Product Change Notification (PCN)

PCN Number: PCN_FePBF_20261017 Affected Series: WE-PBF Affected Part Number: see table "PART NUMBER, REVISION & DATASHEET" PCN Date: 2026-07-17 (YYYY-MM-DD) Effective Date: 2026-10-17 (YYYY-MM-DD)	Change Category: ☐ Equipment/Location ☒ General Data ☐ Material ☐ Process ☐ Product Design ☐ Shipping/Packaging ☐ Supplier ☐ Software
Contact: Product Management Phone: +49 (0) 7942 - 945 5001 Fax: +49 (0) 7942 - 945 5179 E-Mail: pcn.eisos@we-online.com	Datasheet Change: ☒ Yes ☐ No Attachment: ☐ Yes ☒ No

Before change	After change
Recommended Land Pattern:

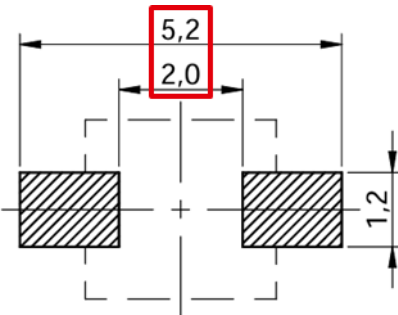
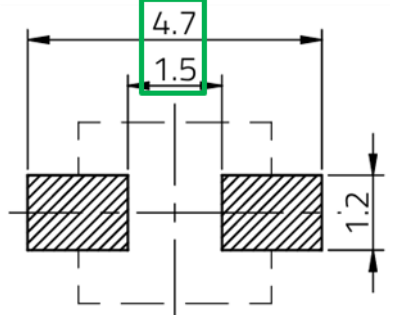
As a datasheet information amendment, Würth Elektronik eiSos corrects the recommended land pattern of the WE-PBF 7427933.
